Proposed Text Changes for Clause 12

1. 2.4 GHz ISM Band Direct Sequence Spread Spectrum Physical Layer Specification

Figure 12-8: PLCP Receive State Machine

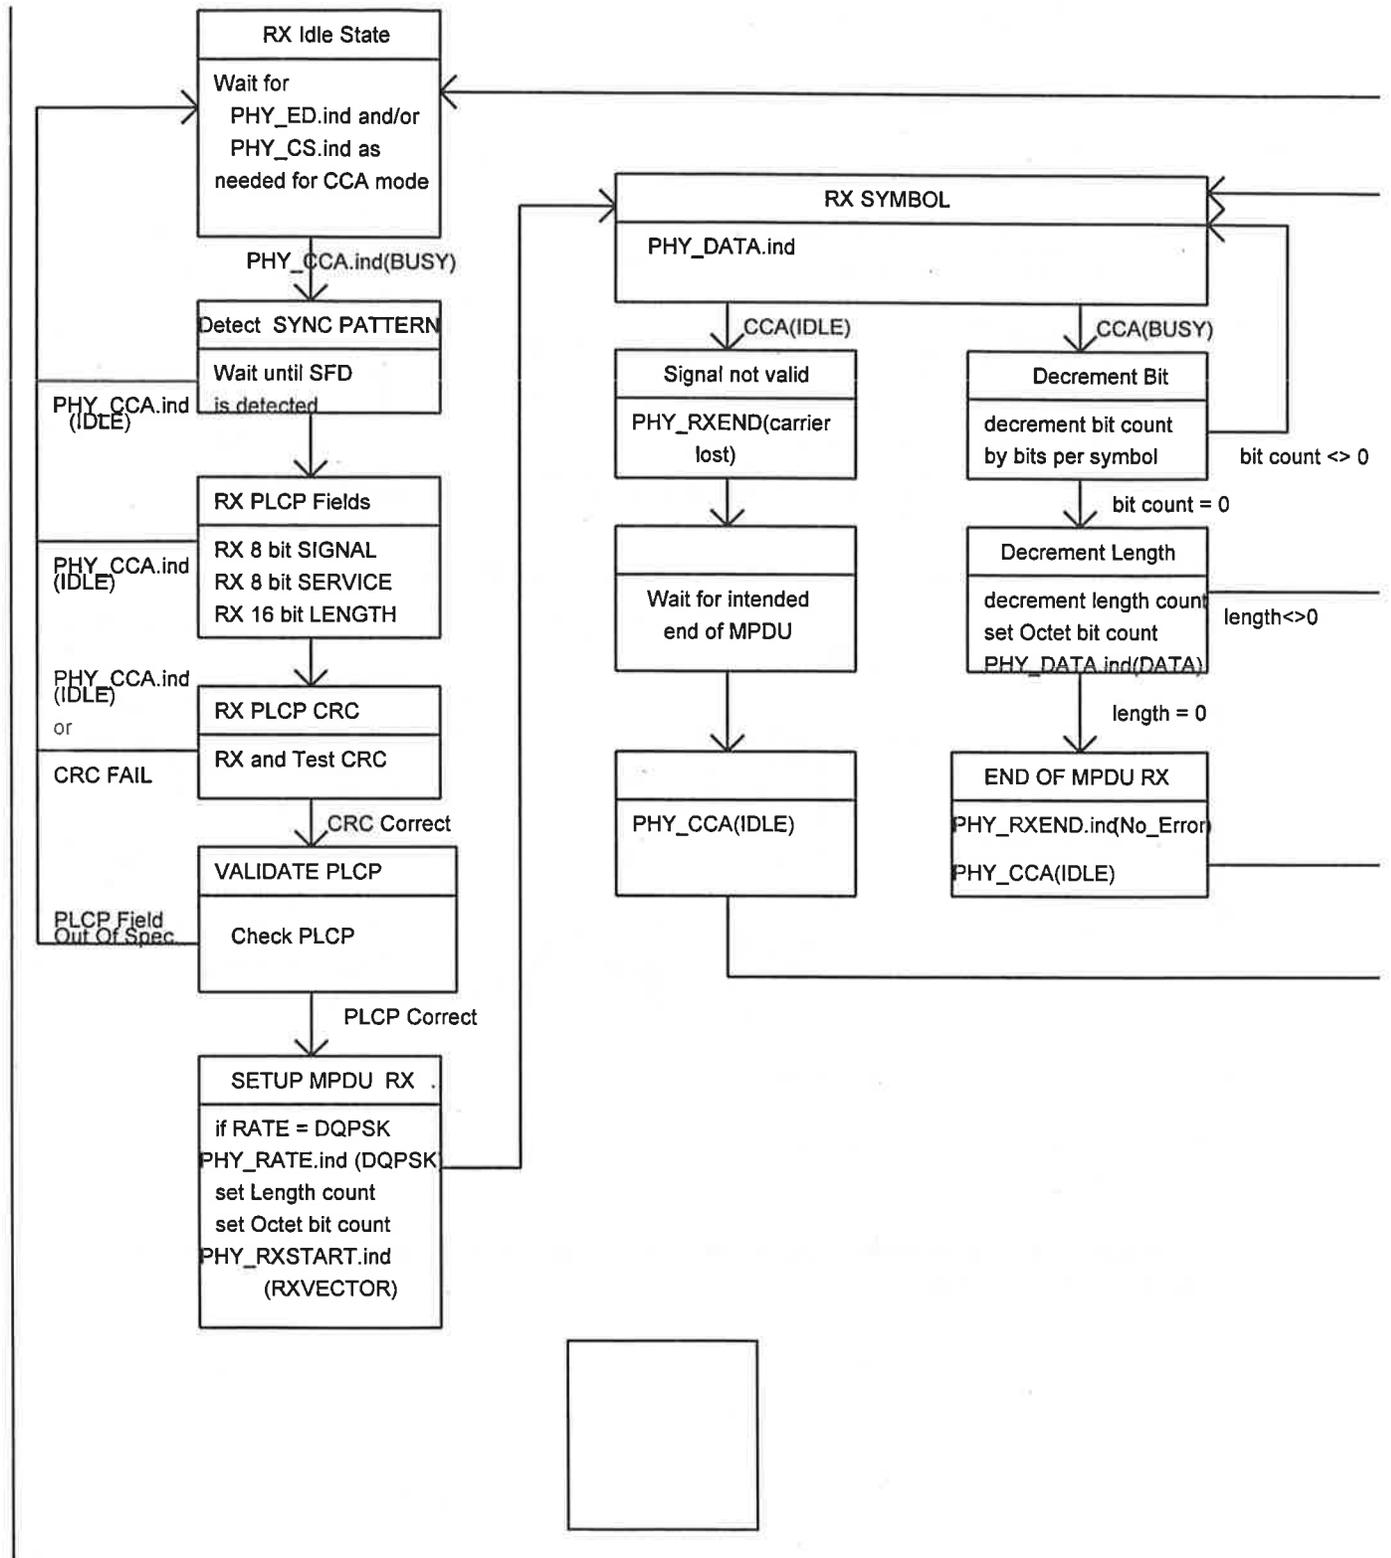
A typical state machine implementation of the PLCP ~~receive~~^{transmit} procedure is provided in Figure 12-8.
